RENESAS TECHNICAL UPDATE

Product Category	MPU/MCU	Document No.	TN-SY*-A0049A/E	Rev.	1.00	
Title	Errata for User's Manual regarding the IIC	Information Category	Technical Notification			
Applicable Product	Renesas Synergy™ S3A6 MCU Group	Lot No. All	Reference Document	S3A6 Microcontroller Group User's Manual Rev.1.20		User's

The specified Renesas Synergy S3A6 User's Manual has incorrect statements about the IIC.

Page 835 of 1444

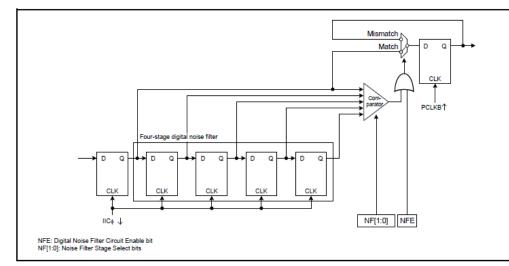
Incorrect

The IIC can also set the AL flag to indicate the detection of arbitration loss during NACK transmission in master mode or during data transmission in slave mode.

The IIC can also set the AL flag to indicate the detection of arbitration loss during NACK transmission in master mode or during data transmission in slave mode.

Page 862 of 1444

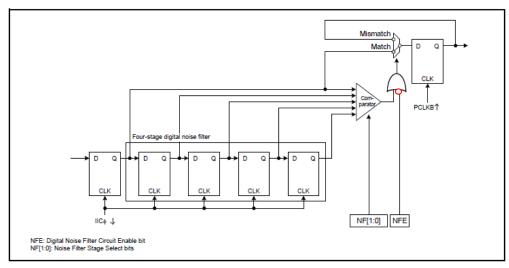
Incorrect Figure

Correct Figure

Page 865 of 1444

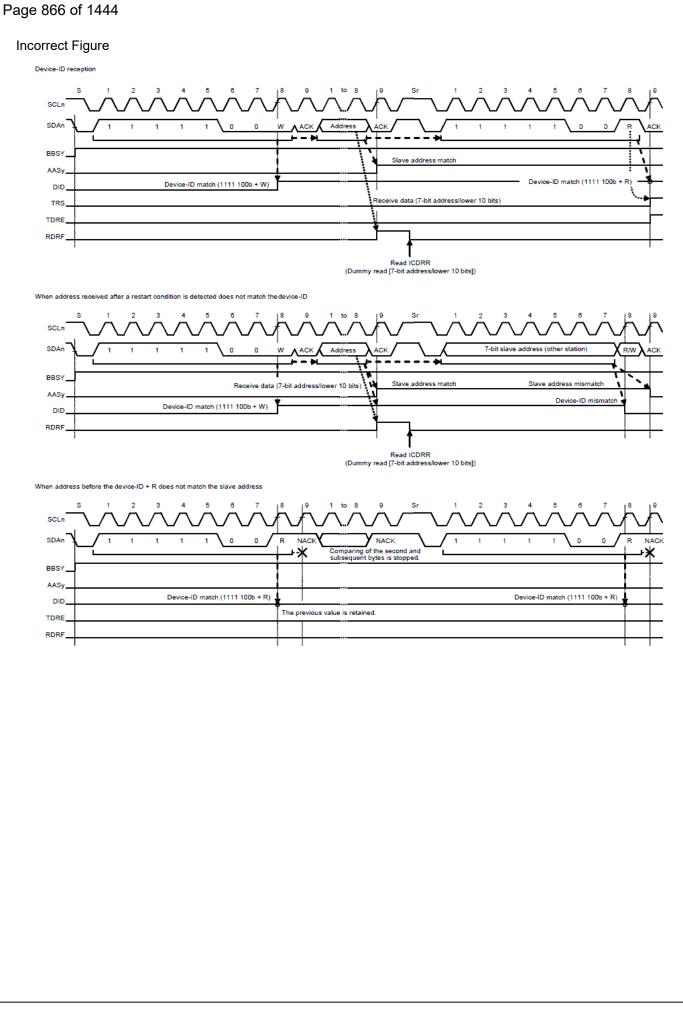
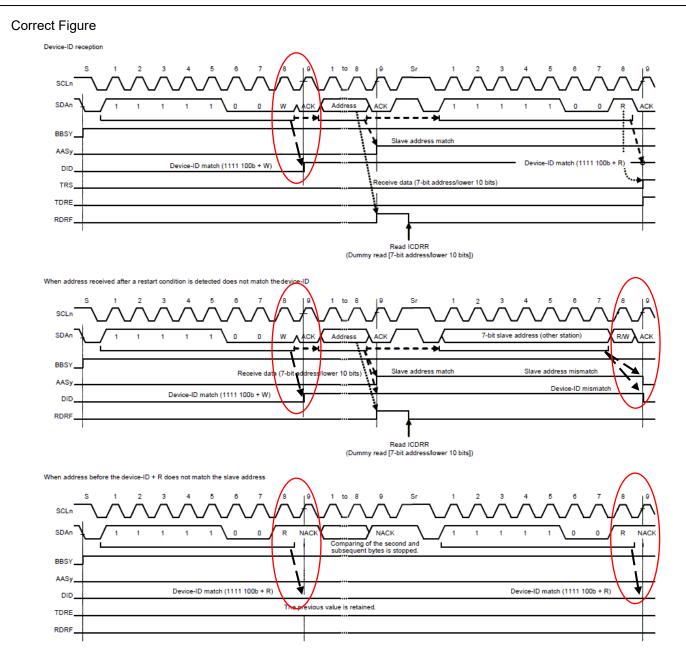
Incorrect

The IIC module provides detection of device ID address in conformance with the I2C bus specification, Rev.03. When the IIC receives 1111 100b as the first byte after a start condition or restart condition is issued with the DIDE bit in ICSER set to 1, the IIC recognizes the address as a device ID, sets the DID flag in ICSR1 to 1 on the rising edge of the 8^{tth} SCL clock cycle when the following R/W# bit is 0, then compares the second and subsequent bytes with its own slave address.

The IIC module provides detection of device ID address in conformance with the I2C bus specification, Rev.03. When the IIC receives 1111 100b as the first byte after a start condition or restart condition is issued with the DIDE bit in ICSER set to 1, the IIC recognizes the address as a device ID, sets the DID flag in ICSR1 to 1 on the rising edge of the 9th SCL clock cycle when the following R/W# bit is 0, then compares the second and subsequent bytes with its own slave address.

Page 887 of 1444

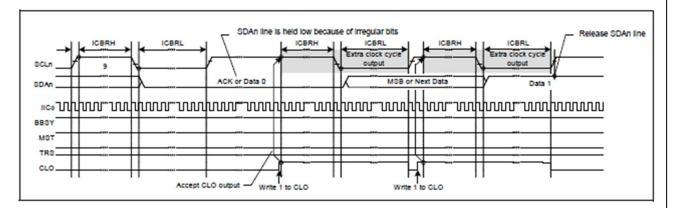
Incorrect

Use this function with the MALE bit in the ICFER register set to 0 (master arbitration-lost detection disabled). If the MALE bit is set to 1 (enabled), arbitration is lost when the value of the ICCR1.SDAO bit does not match the state of the SDAn line.

Use this function with the MALE bit in the ICFER register set to 0 (master arbitration lost detection disabled). If the MALE bit is set to 1 (enabled), arbitration is lost when the value of the ICCR1.SDAO bit does not match the state of the SDAn line.

Page 888 of 1444

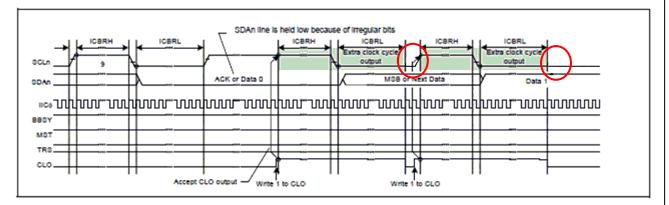
Incorrect Figure

Correct Figure
